780 BLANSHARD - REHABILITATION + ADDITION

HAV00034 CONCURRENT WITH REZ00825

Bubbled areas indicate revisions compared to the previously submitted plans

DATE	REV	ISSUE DESCRIPTION
2022-02-24	1	REZONING PRE-APPLICATION
2022-06-01	2	OPEN HOUSE PROGRESS SET
2022-06-21	3	REZONING APPLICATION
2023-03-23	4	HAP & REZONING RESUBMISSION

LEVEL 5 FLOOR PLAN

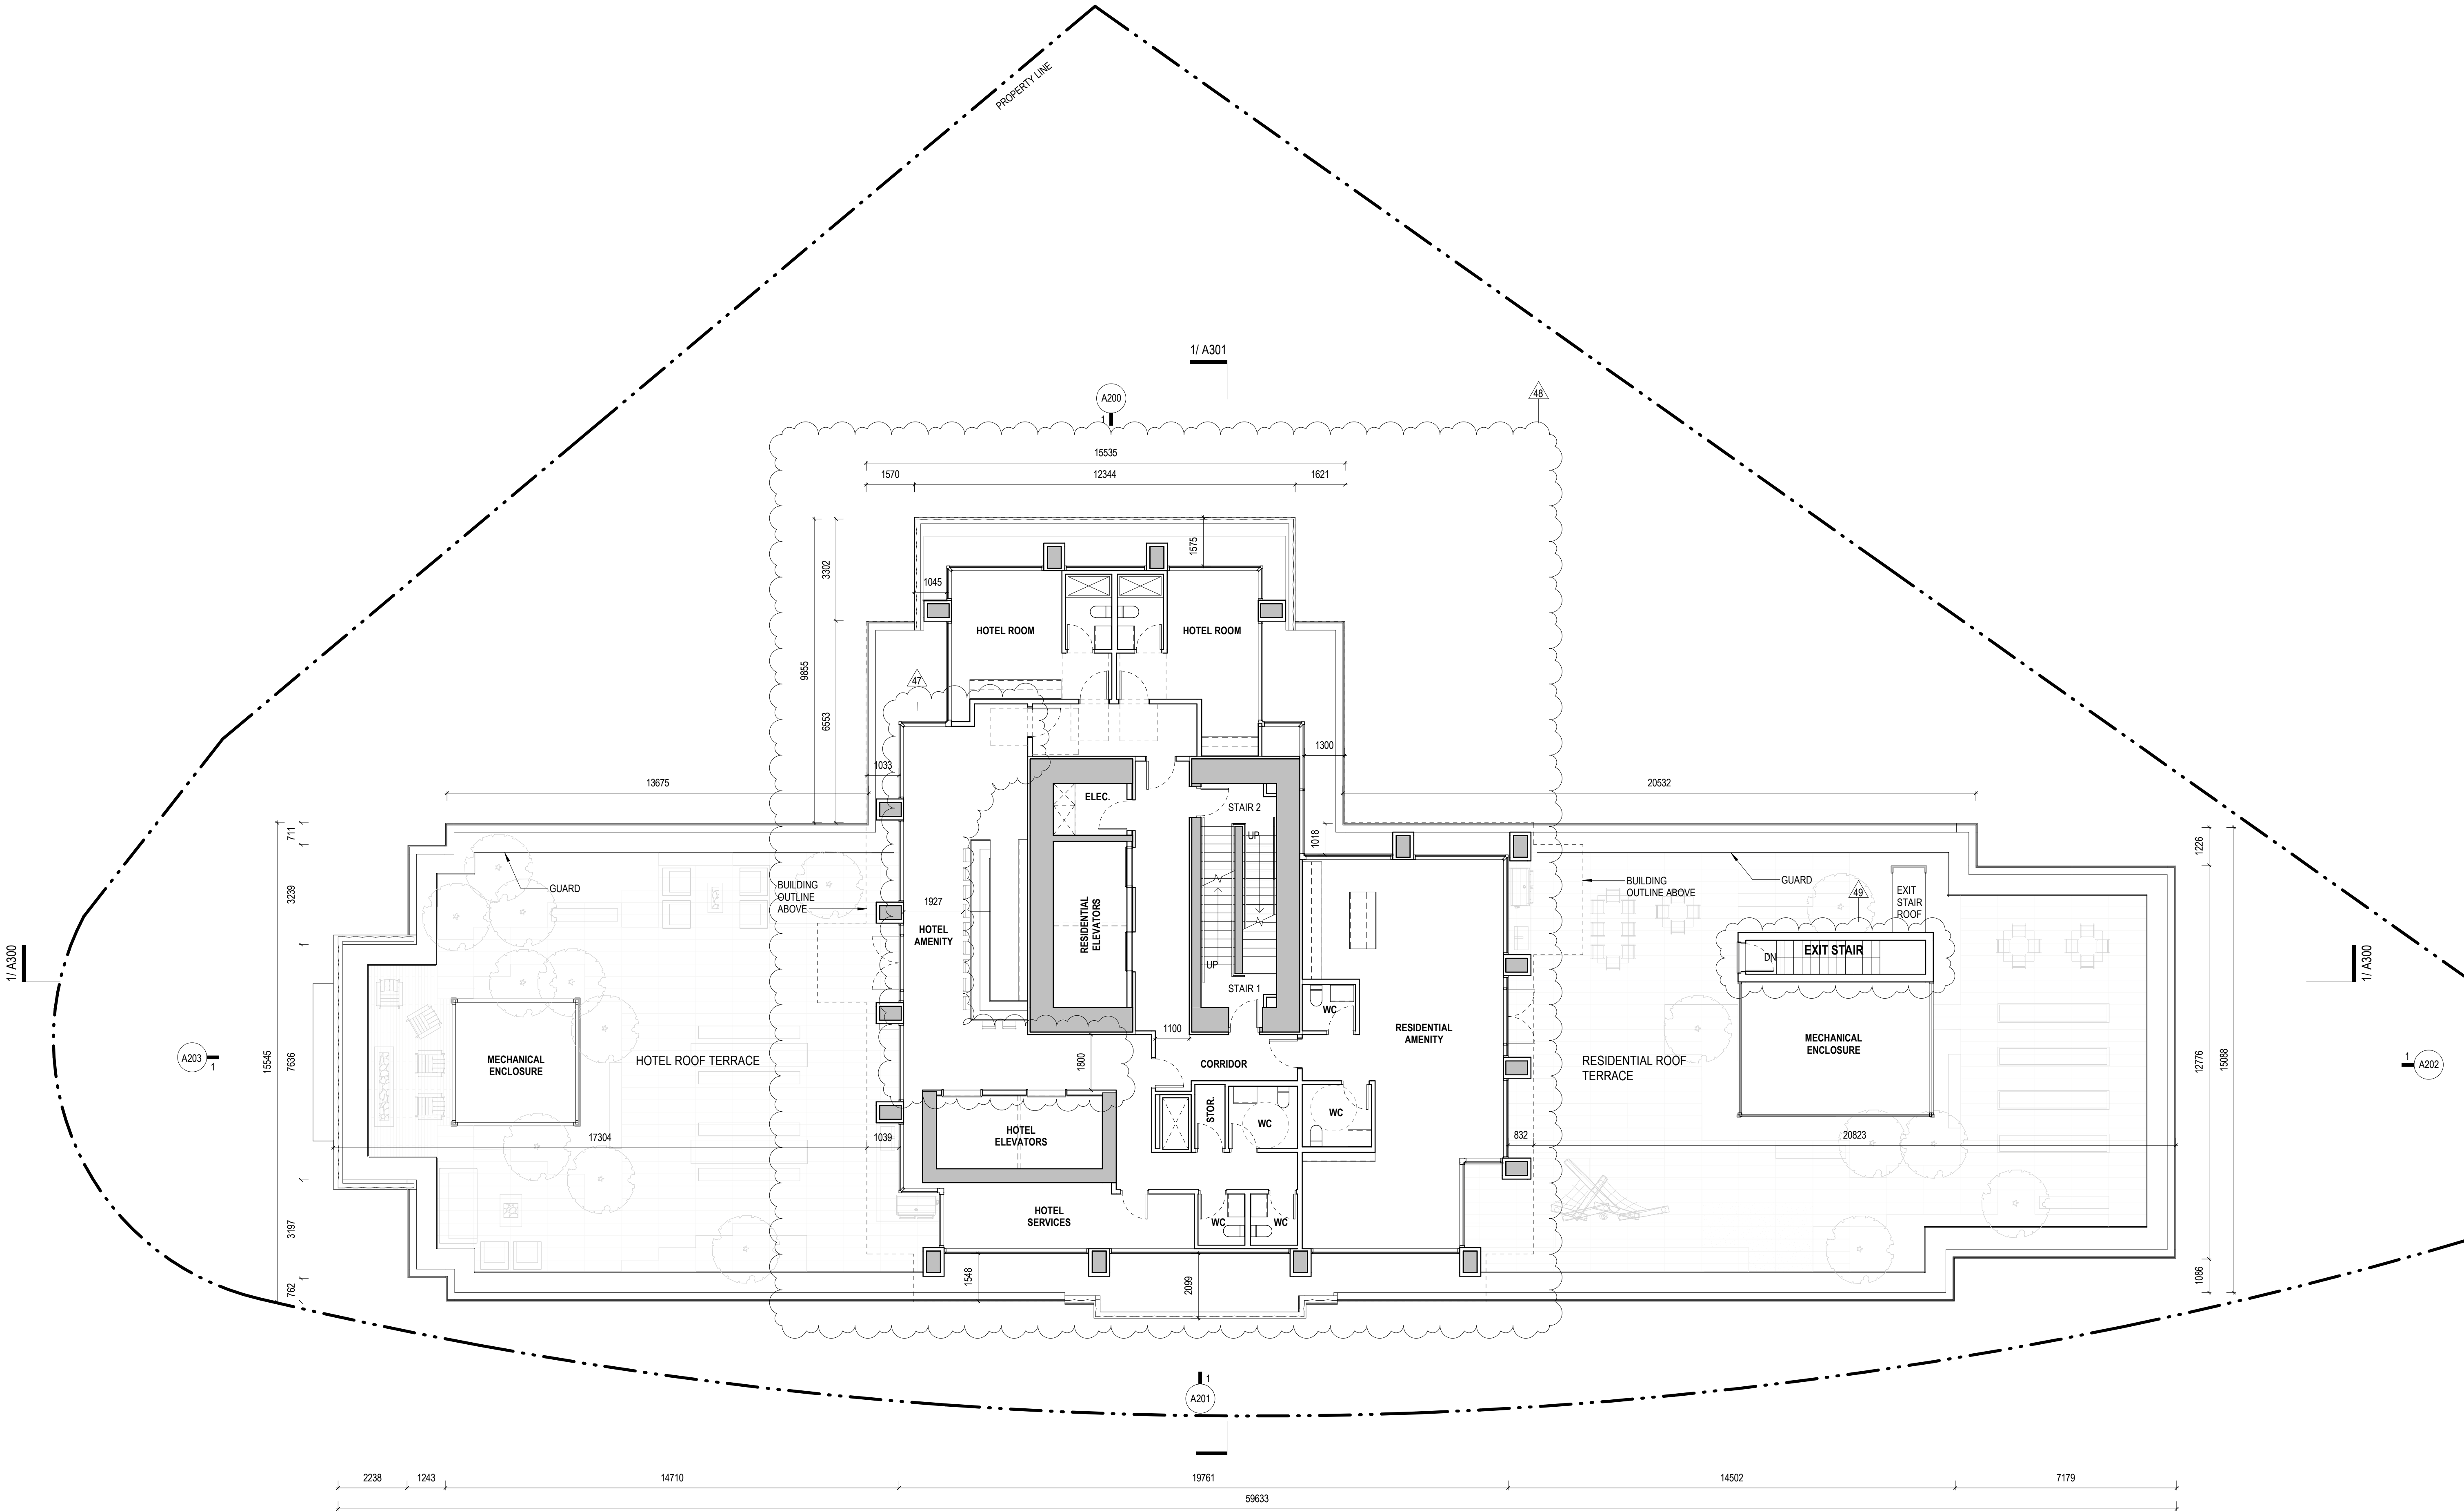
47. Clear width provided in conformance with BCBC 3.3.1.9 per ARS comment #111.

48. The inset face of the glazed facade at Level 05 has been updated for the revised building massing and to respond to ARS Comment #23. See additional visualizations and rationale in response Letter and Sections 10 and 11 of the Large Project Supplementary Information Booklet.

49. To address updated planning and ARS Comment #119, stair extended to roof to ensure access to exit for rooftop deck occupants.

LEVEL 6 FLOOR PLAN

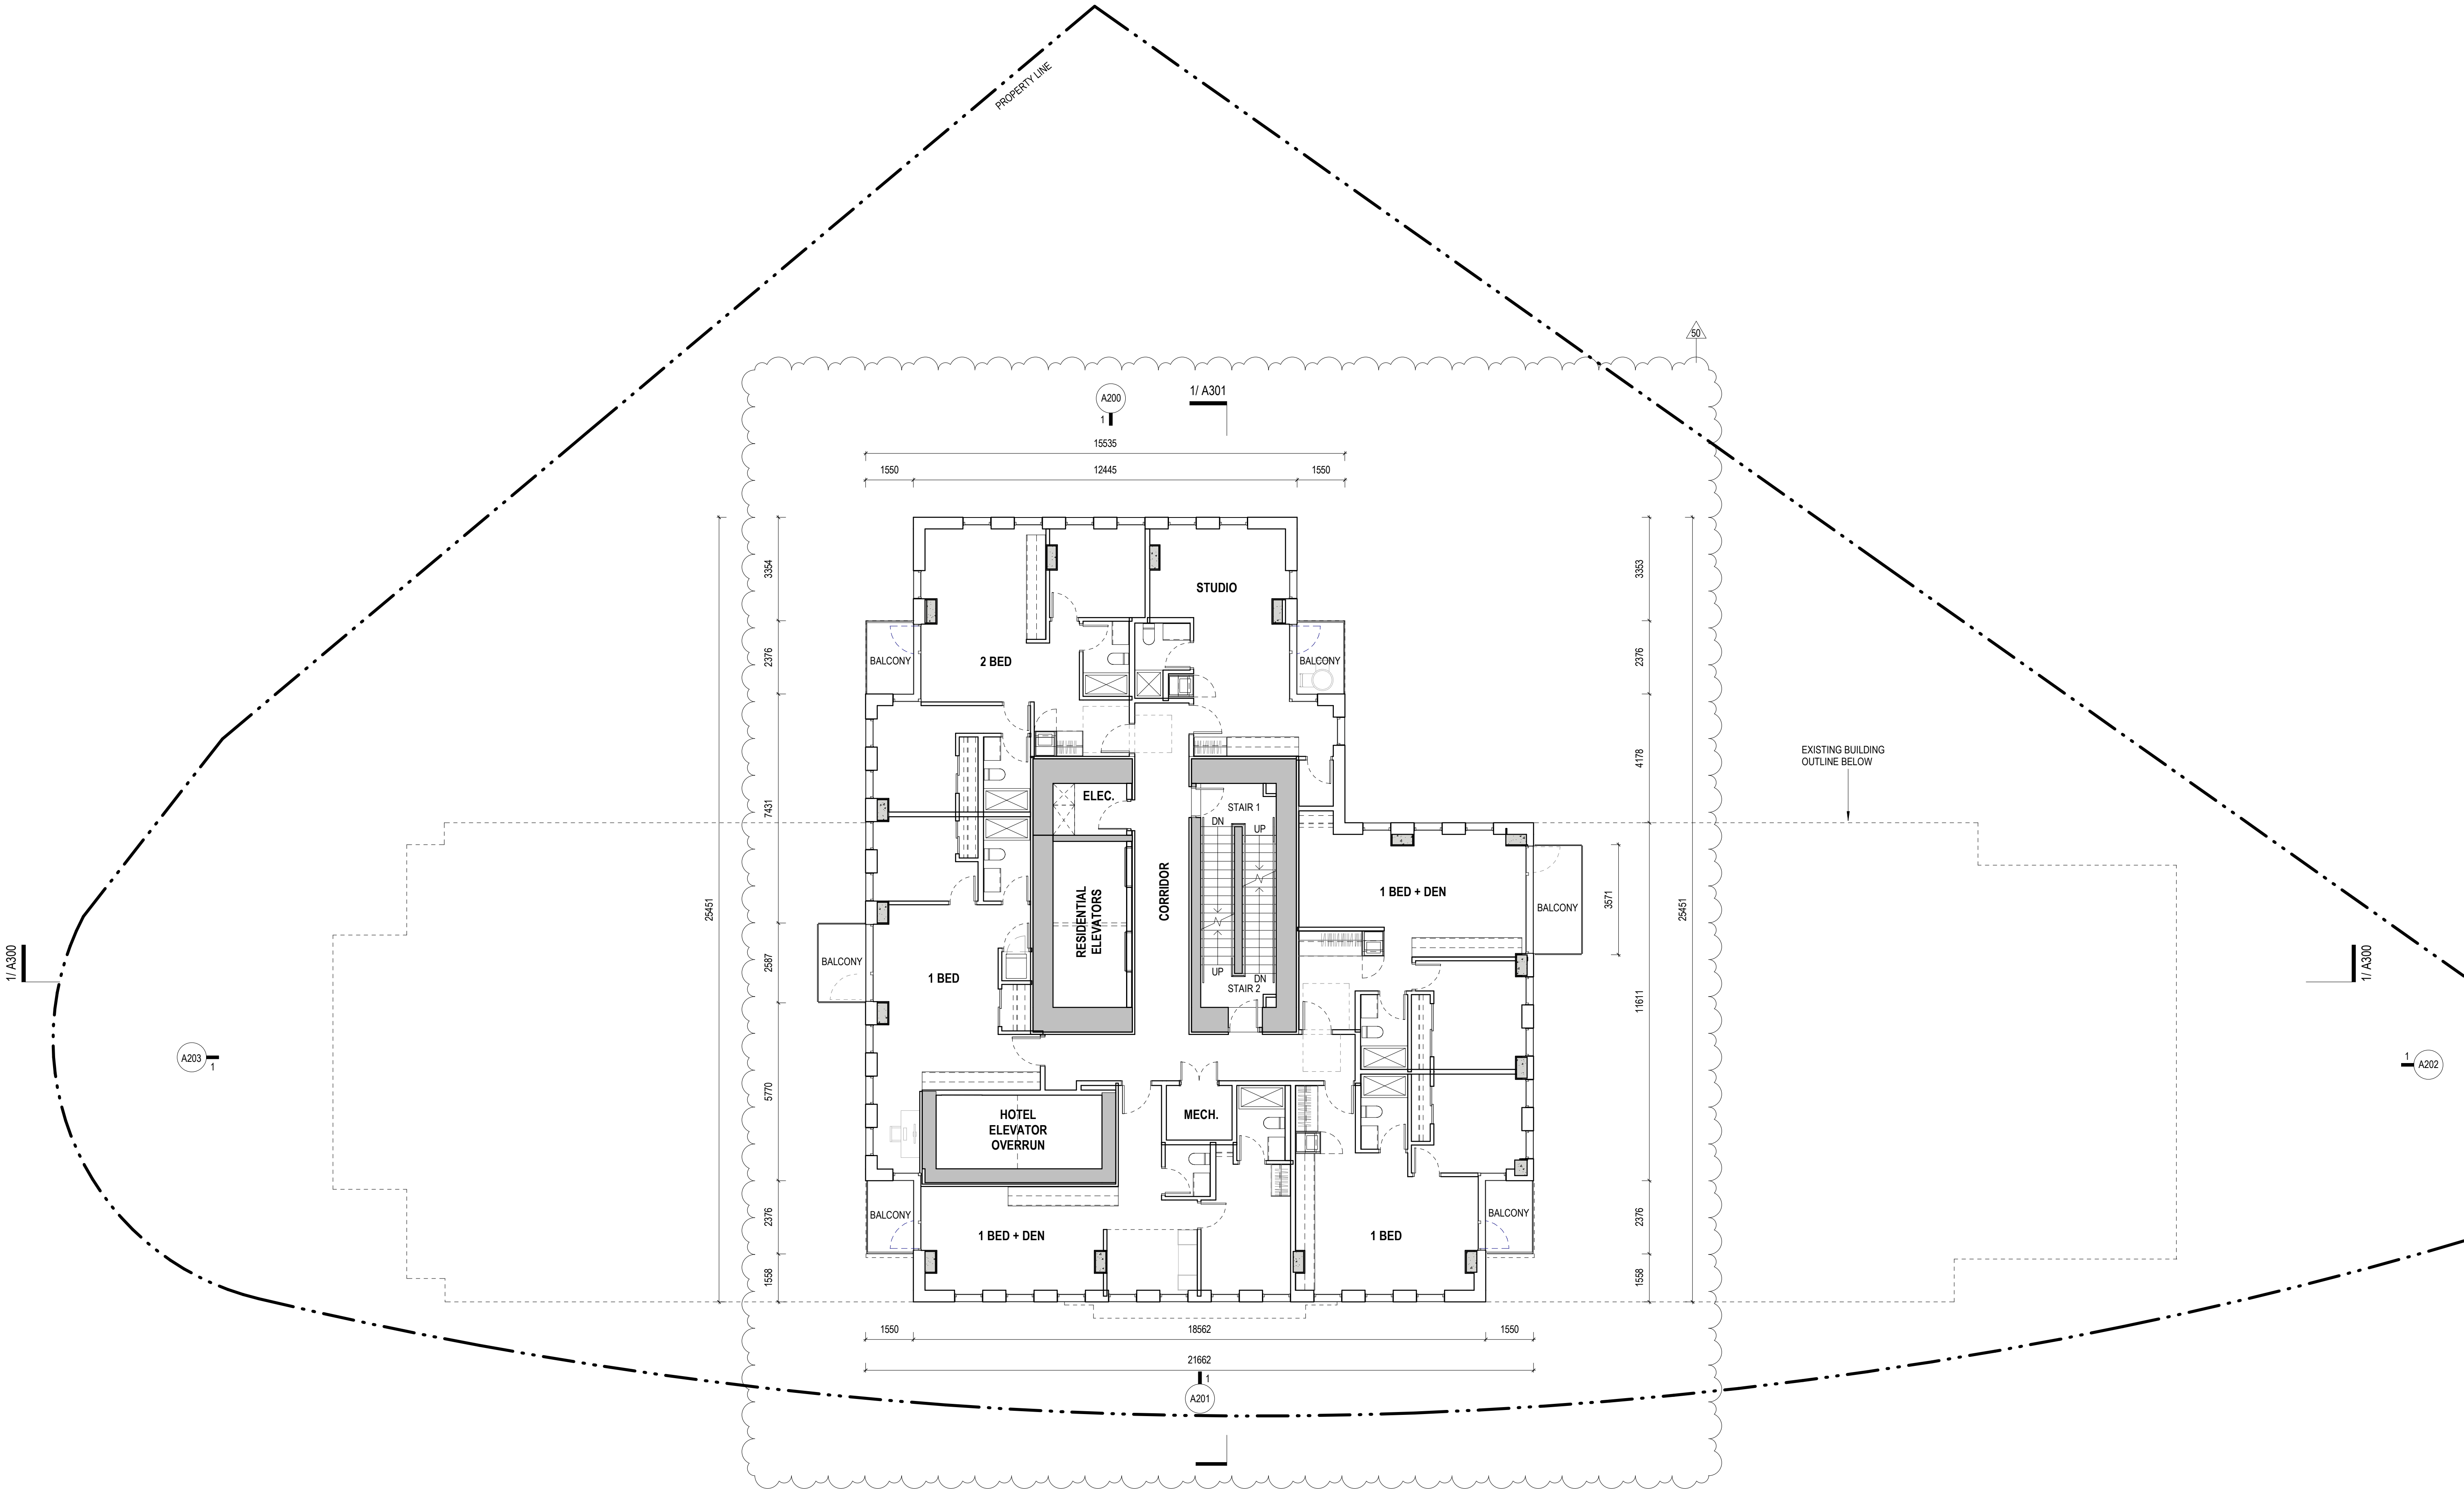
50 Residential tower floor plate design and suite mix revised to suit new massing developed in response to ARS Comments #22, #23, and #24. See also Response Letter and Sections 10 and 11 in Large Project Supplementary Information Booklet.

ROOF PLAN

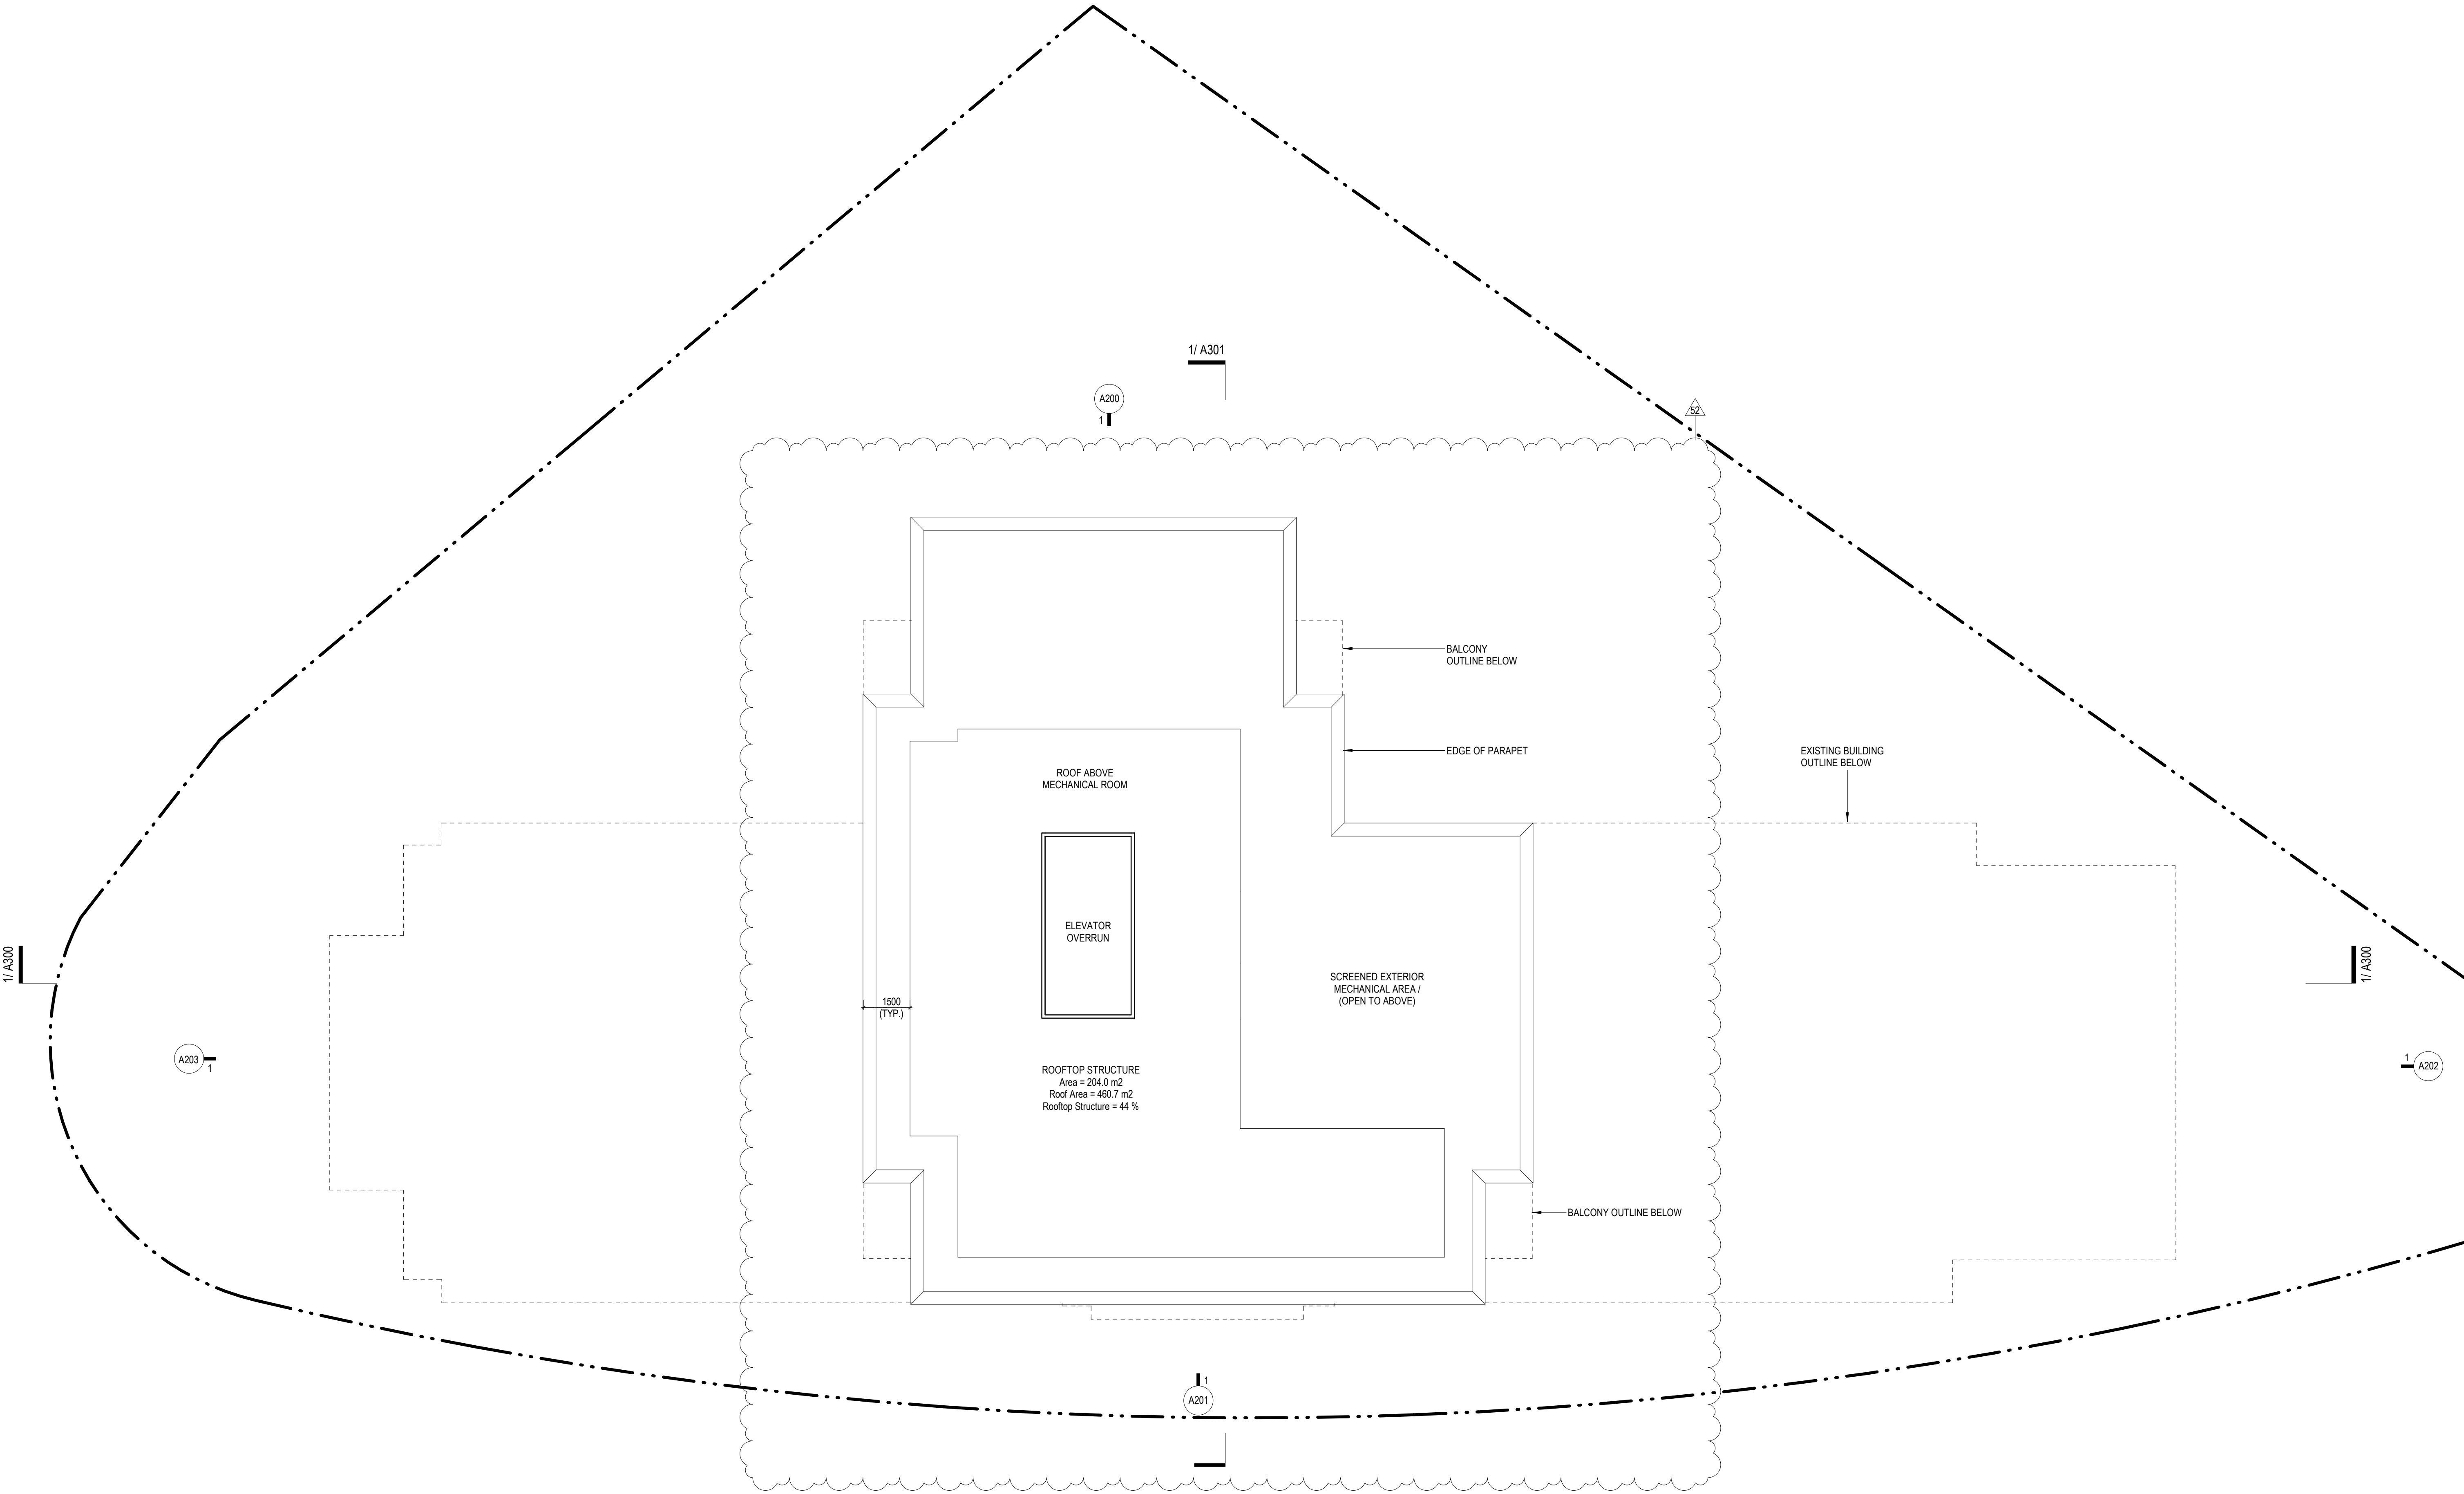
S2 Rooftop design shows revised mechanical room and equipment to suit revised massing and tall parapet all around to respond to ARS Comment #25.
